# Access Compliance Report

## Public Rights-of-Way

### (Curb Ramps)

Intersection ID: 24214	Main Street: HENSEY'S_WY	Cross Street: BEVERLY_CREST_BV	Location: W
ADA ID: 8E772869F556	Ramp Type: Perpendicular	Initial Pass/Fail: Fail	Overall Compliance: No
Severity Score: 12.5			
Codes/Mitigation Info/Possible Solution		Field Measurements/Component Compliance

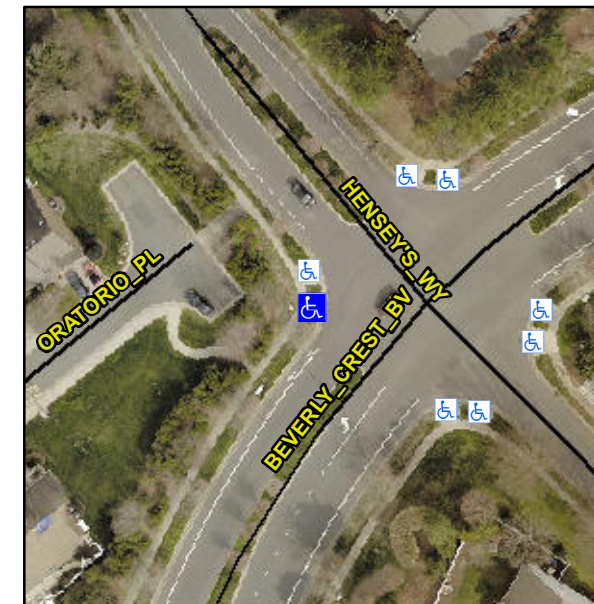
**Not Found, R304.2.2**

Compliance	Description	Data	Compliance	Description	Data
N/A	Ramp Length (in)	96.0	No	Ramp Slope (%)	9.0
Yes	Ramp Width (in)	66.0	Yes	Ramp XSlope (%)	1.2
N/A	Flare Type LT	N/A	N/A	Flare Type RT	N/A
N/A	Flare Slope LT (%)	N/A	N/A	Flare Slope RT (%)	N/A
N/A	Flare Traversable LT?	N/A	N/A	Flare Traversable RT?	N/A
N/A	Landing Length (in)	N/A	N/A	DWS Provided?	N/A
N/A	Landing Width (in)	N/A	N/A	DWS Contrast?	N/A
N/A	Landing Slope (%)	N/A	N/A	DWS Length (in)	N/A
N/A	Landing X Slope (%)	N/A	N/A	DWS Full Width?	N/A
N/A	Landing Curb? (Y/N)	N/A	N/A	DWS Offset (in)	N/A
N/A	Shared Landing?	N/A			
N/A	Gutter Ponding?	N/A	N/A	Gutter Slope (%)	N/A
N/A	Gutter Lip Ht (in)	N/A	N/A	Gutter X Slope (%)	N/A
N/A	Painted X Walk1?	No	N/A	Painted X Walk2?	N/A
	X Walk 1 Direction	To SE		X Walk 2 Direction	N/A
N/A	X Walk 1 Width (in)	N/A	N/A	X Walk 2 Width (in)	N/A
	X Walk 1 Slope (%)	1.6		X Walk 2 Slope (%)	N/A
	X Walk 1 X Slope (%)	0.2		X Walk 2 X Slope (%)	N/A

**Remove & Replace Entire Ramp.**
